Technical Service Bulletin (TSB)
High Pressure Fuel Pump

REFERENCE:	TSB: 14-002-26 REV. A GROUP: 14 - Fuel System	Date:	July 8, 2026	REVISION:	14-002-26
VEHICLES AFFECTED:	2022 - **2027** (B1) Jeep Renegade 2022 - **2027** (H1) Jeep Commander 2022 - **2027** (M1) Jeep Compass This bulletin applies to vehicles equipped with a 1.3 I4 Turbo MAIR DI Engine (Sales Code EYJ).			MARKET APPLICABILITY: ☐ NA☐ MEA ☒ SA☐ IAP ☐ EE☐ CH NOTE: This bulletin applies to the Brazilian market.	
CUSTOMER SYMPTOM:	Customers must experience a Malfunction Indicator Lamp (MIL) illumination and the vehicle must exhibit/set one or more of the following Diagnostic Trouble Codes (DTCs): ● P0087-00 - Sensor De Pressão Da Linha De Combustível - Banco 1 - Pressão Abaixo Do Limite. ● P0088-00 - Sensor De Pressão Da Linha De Combustível - Banco 1 - Pressão Acima Do Limite. ● P0089-00 - Sensor De Pressão Da Linha De Combustível 1 - Desempenho. Customers may also comment on one or more of the following: ● Unstable idle. ● The engine is running rough. ● Partial loss of engine power.

This bulletin supersedes Technical Service Bulletin (TSB) 14-002-26, date of issue March 13, 2026, which should be removed from your fi

Fig. 1

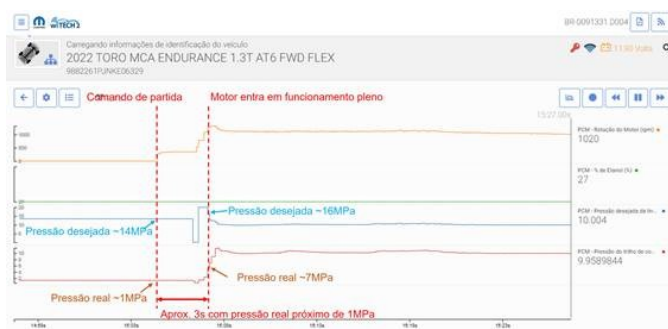
1. Position the vehicle at the workplace.
2. Open the engine hood.
3. Fit the bodyguards (fenders and front bumpers).
4. Run the motor up to the working temperature.
5. Connect wiTECH to the vehicle.
6. Access the injection ramp pressure values in the injection control module (ECM) in graphical mode. To do this, choose the following parameters:
 - Engine speed (or engine speed).
 - Fuel rail pressure (or Fuel pressure instruction on common ramp high fuel pressure).
 - Desired Fuel Line Pressure (or Common Fuel Injection Chute Pressure).
7. Observe if the graph read on the vehicle is as shown in the images of the examples below.

Graphical Mode - KO Result

8. Monitor wiTECH whether the high-pressure fuel pump will deliver the desired pressure immediately at the time of start-up when the failure occurs:
9. Is there a delay in the pressure increase or does the actual pressure not reach the desired pressure?

- YES >>> Print or capture the image (print screen) showing the injection ramp pressure loss failure with the parameters "Fuel rail pressure" and "Desired fuel line pressure" (for possible warranty submission) and proceed to the next step.

- NO >>> **Do not apply for this TSB.**
10. Disconnect the contact (key-off).
11. Mount the pressure gauge on the low-pressure line between the fuel line and the inlet of the high-pressure fuel pump.
